Access Compliance Report

Public Rights-of-Way

Intersection ID: 31876	Main Street: ARABELLA_DR	Cross Street: WILLIAMS_GLENN_RD	Location: NE
ADA ID: 6DDEA343D456	Ramp Type: PerpDiag	Initial Pass/Fail: Fail	Overall Compliance: No
		Severity Score: 10

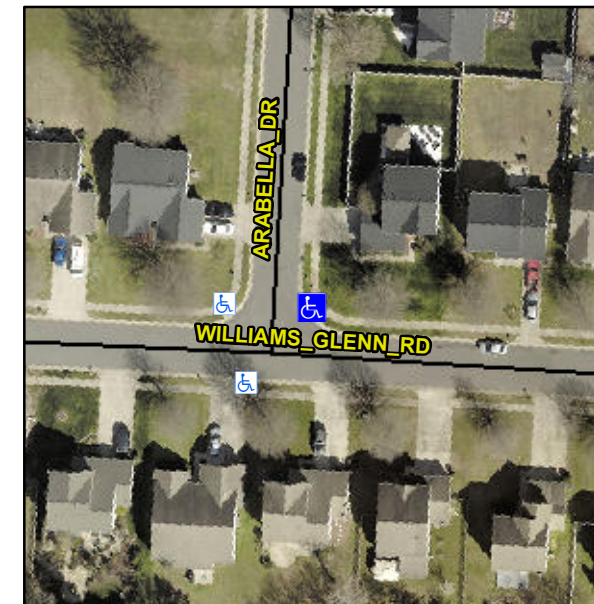
Not Found, R304.5.1, R304.5.3

Compliance	Description	Data	Compliance	Description	Data
N/A	Ramp Length (in)	47.5	Yes	Ramp Slope (%)	5.1
No	Ramp Width (in)	46.0	No	Ramp XSlope (%)	2.7
N/A	Flare Type LT	N/A	N/A	Flare Type RT	N/A
N/A	Flare Slope LT (%)	N/A	N/A	Flare Slope RT (%)	N/A
N/A	Flare Traversable LT?	N/A	N/A	Flare Traversable RT?	N/A
N/A	Landing Length (in)	N/A	N/A	DWS Provided?	N/A
N/A	Landing Width (in)	N/A	N/A	DWS Contrast?	N/A
N/A	Landing Slope (%)	N/A	N/A	DWS Length (in)	N/A
N/A	Landing X Slope (%)	N/A	N/A	DWS Full Width?	N/A
N/A	Landing Curb? (Y/N)	N/A	N/A	DWS Offset (in)	N/A
N/A	Shared Landing?	N/A			
N/A	Gutter Ponding?	N/A	N/A	Gutter Slope (%)	N/A
N/A	Gutter Lip Ht (in)	N/A	N/A	Gutter X Slope (%)	N/A
N/A	Painted X Walk1?	No	N/A	Painted X Walk2?	No
	X Walk 1 Direction	To NW		X Walk 2 Direction	To SW
N/A	X Walk 1 Width (in)	N/A	N/A	X Walk 2 Width (in)	N/A
	X Walk 1 Slope (%)	0.0		X Walk 2 Slope (%)	0.7
	X Walk 1 X Slope (%)	2.2		X Walk 2 X Slope (%)	1.4

Remove & Replace Curb Ramp With Two New Directional Ramps or Equivalent.
